# Antenna Information for Council planners

## Antenna Coverage and Design – Camden Planners Questions

### London Borough of Camden Planners Antenna Questions

### Plan view (Birds eye view) of a 3 sector (antenna) cell site with *correct* vertically mounted antennas

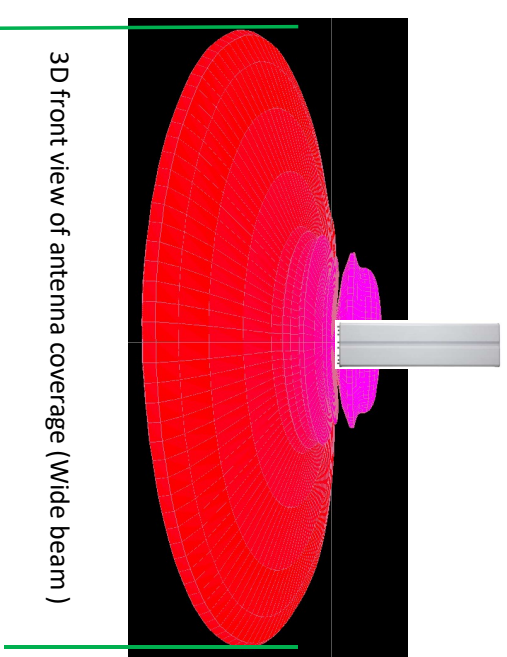
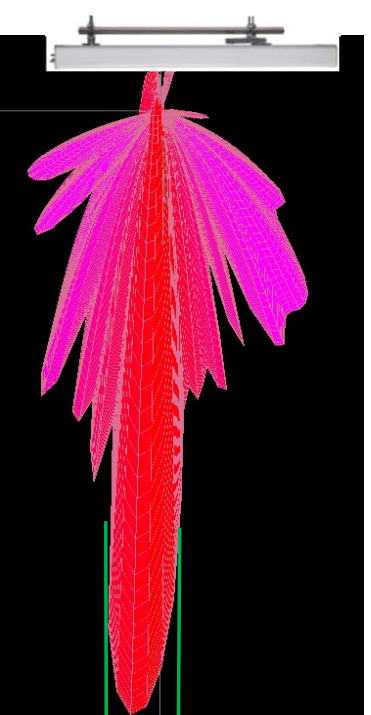
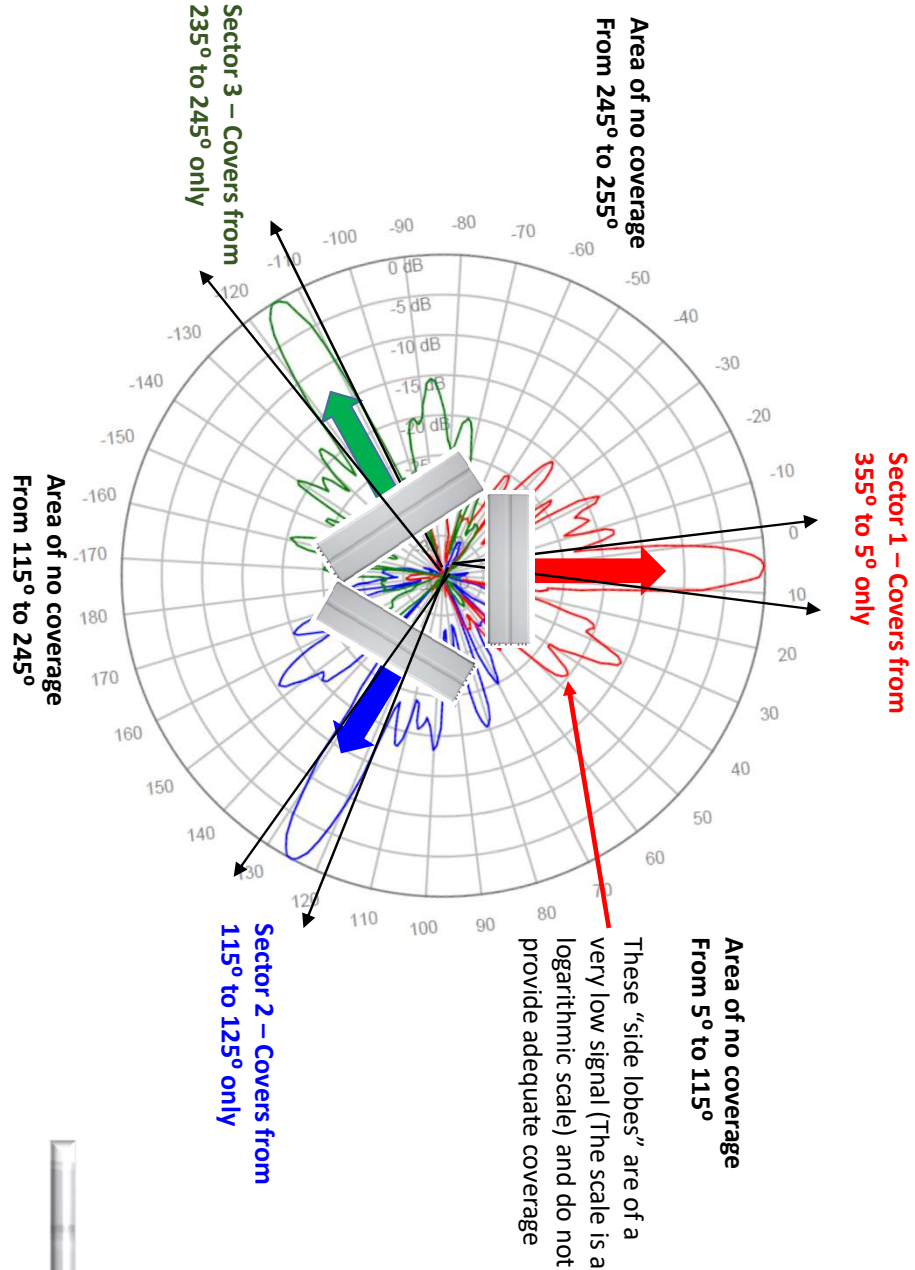
1. Camden do not believe that antennas cannot operate horizontally. Could you explain why antennas are not installed horizontally, and the ramifications if we were to adopt such a configuration?

Each antenna covers a nominal 120° area, so 3 antennas, mounted 120° apart, covers the full 360° area. The antenna coverage is similar to a disc, or plate, it is very wide (120°) in the azimuth (Horizontal plane ), and very narrow (10°) in the elevation (vertical plane)
